Agenda Item # 7

SUB-002911-2024 & SUB-SW-002912-2024

Foxglove Subdivision

- Subdivision approval to create 109 legal lots of record.
- Waive construction of a sidewalk along all street frontages.

SITE PLAN

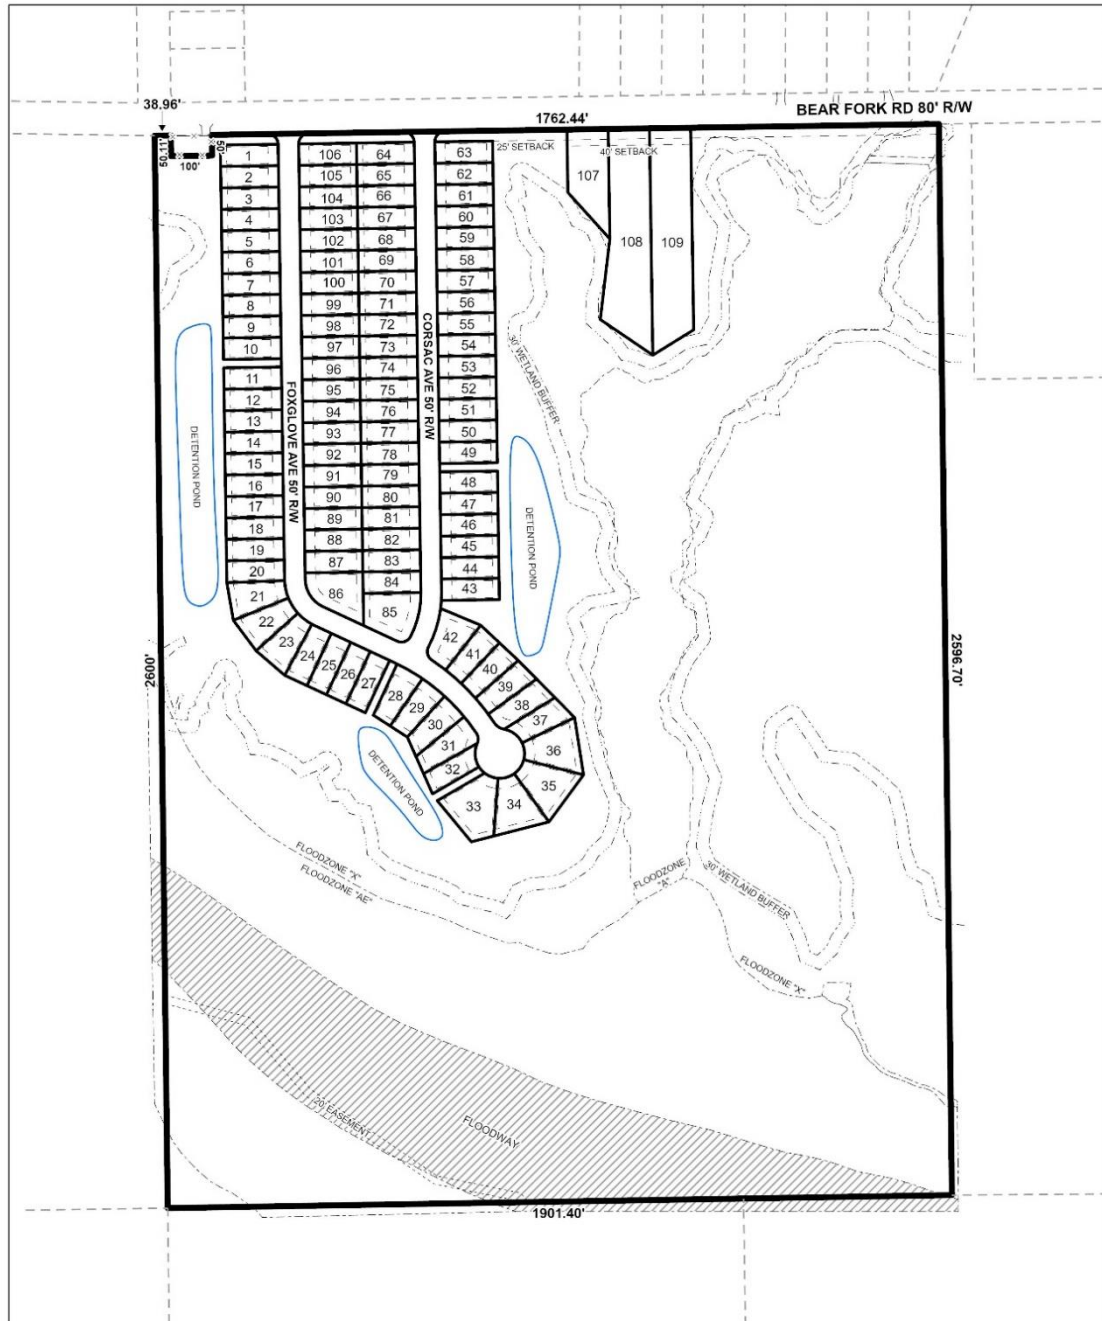
Three of the proposed lots (107, 108 and 109) are separate from the main grouping of lots and would front directly onto Bear Fork Road. These lots have a proposed 40-foot minimum building setback line shown along Bear Fork Road, as well as a 25-foot minimum building setback line. Moreover, the required setbacks data table illustrates 40-feet for lots 93 – 95 (which were the lot numbers on these lots on the first plat). The 25-foot minimum building setback line is the minimum required by the UDC and should be correctly reflected on the final plat, including the required setbacks data table.

The remaining lots have setbacks (front, side and rear) illustrated on each lot. The plat should be revised to remove the side and rear setback lines on these lots. Additionally, if the required setbacks data table is to remain on the final plat, it must be consistent with the setback lines illustrated on the lots, and only reference the 25-foot (front) minimum building setback line.

The preliminary plat does not indicate any lot dimensions for Lots 1 – 106, and provides a lot size for only Lot 108. If approved, the plat should be revised to label each lot with its dimensions, and to also label each lot with its size in both square feet and acres, or a table should be furnished on the plat providing the same information. Proposed Lots 108 and 109 would exceed the depth-to width ratio of Section 6.C.3. of the Subdivision Regulations and would require a waiver of that section, if approved.

The two (2) proposed streets into the subdivision are indicated to each be over 600 feet in length terminating in a cul-de-sac after intersecting. Section 6.B.3. of the Subdivision Regulations states that closed-end streets shall not, ordinarily, be over 600 feet in length. Therefore, if approved, a waiver of Section 6.B.3. would be required. The right-of-way width of all streets should be retained on the Final Plat, if approved. The cul-de-sac is not labeled with its radius on the preliminary plat; therefore, if approved, the cul-de-sac should be labeled with its radius on the Final Plat, or the same information should be provided on a Curve Data table, and approved by the Fire, Engineering and Traffic Engineering Departments.

The Site Data table on the preliminary plat states that there are no common areas; however, one accessway from Foxglove Avenue to the stormwater detention area in the South portion of the site is labeled "Common Area". As the site contains large areas outside the area proposed to be developed, the plat should be revised to identify common areas, and future development areas. All accessways from streets to common areas/stormwater detention areas should also be labeled as "Common Area". A note should be required on the Final Plat, if approved, stating that the maintenance of all common areas and stormwater detention areas is the responsibility of the property owners. Furthermore, as the site contains large areas of wetlands and a floodway, the applicant may consider designating these areas as conservation areas.

The preliminary plat indicates easements in the Southern portion of the site within the floodway. Therefore, if approved, a note should be placed on the Final Plat stating that no structure shall be constructed or placed in any easement without permission of the easement holder.

1. Retention of the right-of-way width of Bear Fork Road and all internal streets on the Final Plat;
2. Correction of the Required Setbacks table;
3. Illustration of the 25-foot minimum building setback line along all street frontages;
4. Revision of the plat to remove the side and rear setback lines for Lots 1 – 106 on the Final Plat;
5. Revision of the plat to label the area between the Bear Fork Road right-of-way and Lots 1, 63, 64 and 106 as Common Area;
6. Revision of the plat to label the lot dimensions on Lots 1 – 106 on the Final Plat;
7. Revision of the plat to label each lot with its size in both square feet and acres, or the furnishing of a table on the Final Plat providing the same information;
8. Revision of the plat to label the cul-de-sac with its radius, or the furnishing of a Curve Data table on the Final Plat providing the same information;

9. Revision of the plat to label all accessways between lots as Common Area;
10. Revision of the plat to label all stormwater detention areas as Common Area;
11. Placement of a note on the Final Plat stating that maintenance of all common areas and stormwater detention areas is the responsibility of the property owners;
12. Placement of a note on the Final Plat stating that no structure shall be constructed or placed in any easement without permission of the easement holder;
13. Compliance with all Engineering comments noted in this staff report;
14. Placement of a note on the Final Plat stating all Traffic Engineering comments noted in this staff report;
15. Compliance with all Urban Forestry comments noted in this staff report; and,
16. Compliance with all Fire Department comments noted in this staff report.

BEARFORK ROAD
TYP. CROSS SECTION

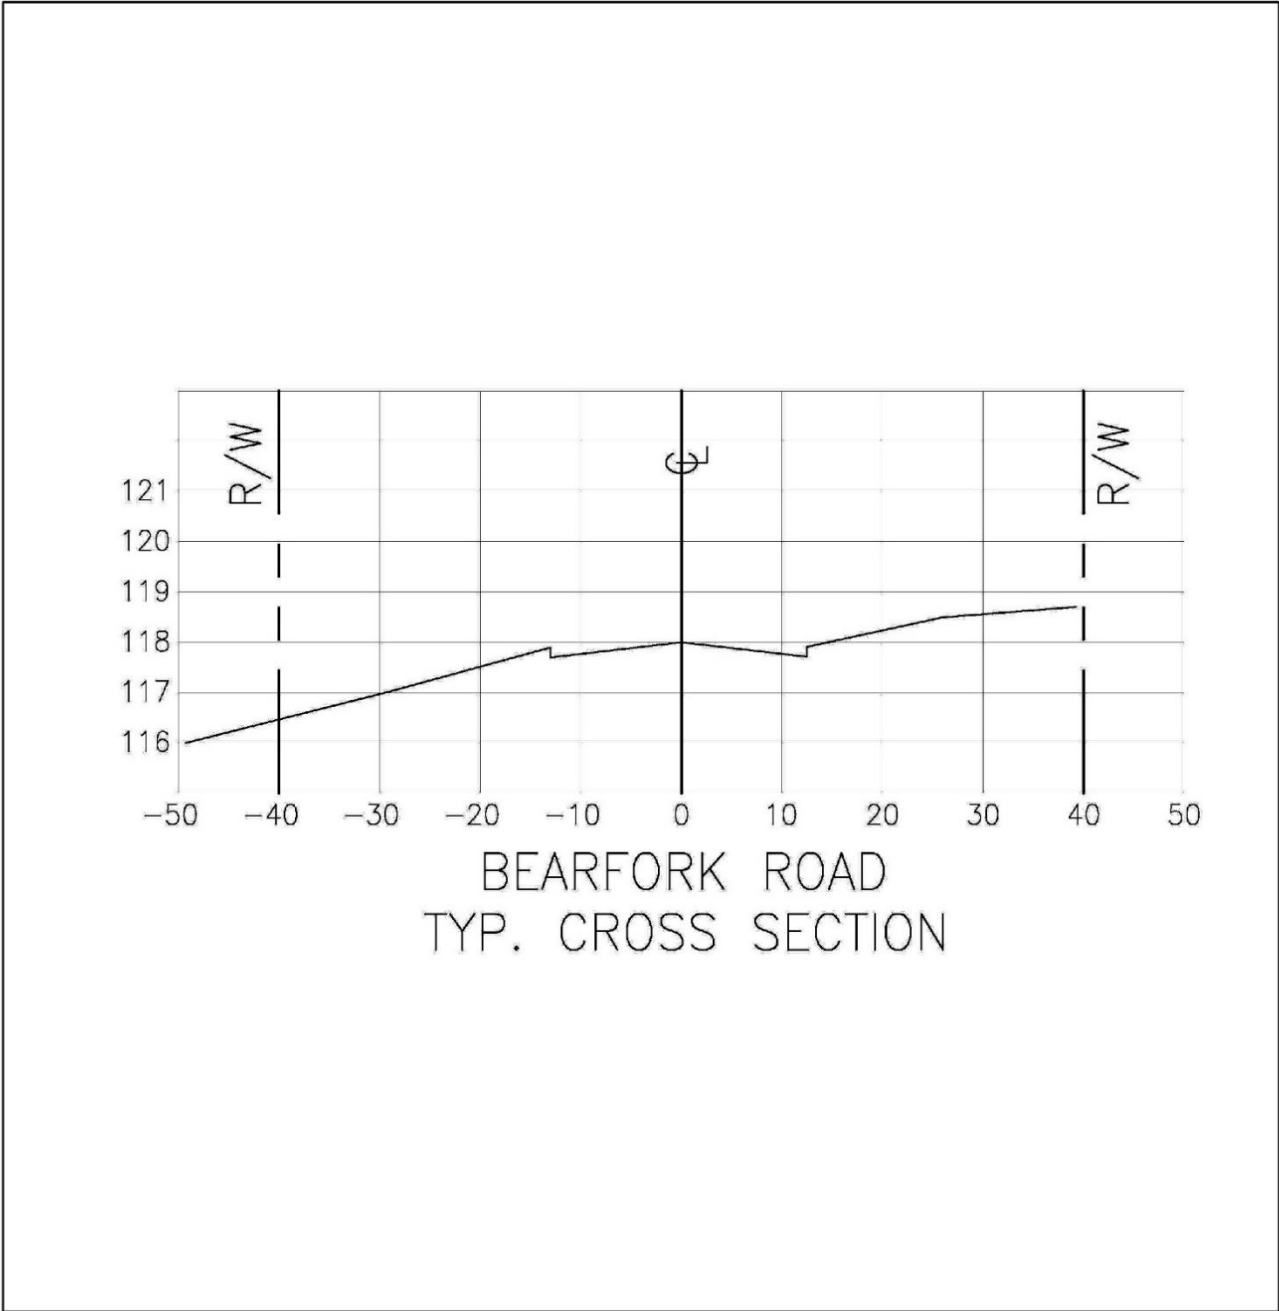
1. It appears that there is sufficient room within the ROW, or within the property, for the construction of a sidewalk along Bear Fork Rd. that could be permitted through the Land Disturbance/ROW Permit process.

While there are no sidewalks within the vicinity of the subject site, the South side of Bear Fork Road is largely undeveloped. Thus, as properties are developed, sidewalks could continue to connect. Engineering states that it appears that there is sufficient room within the ROW, or within the property, for the construction of a sidewalk along Bear Fork Rd. that could be permitted through the Land Disturbance/ROW Permit process.
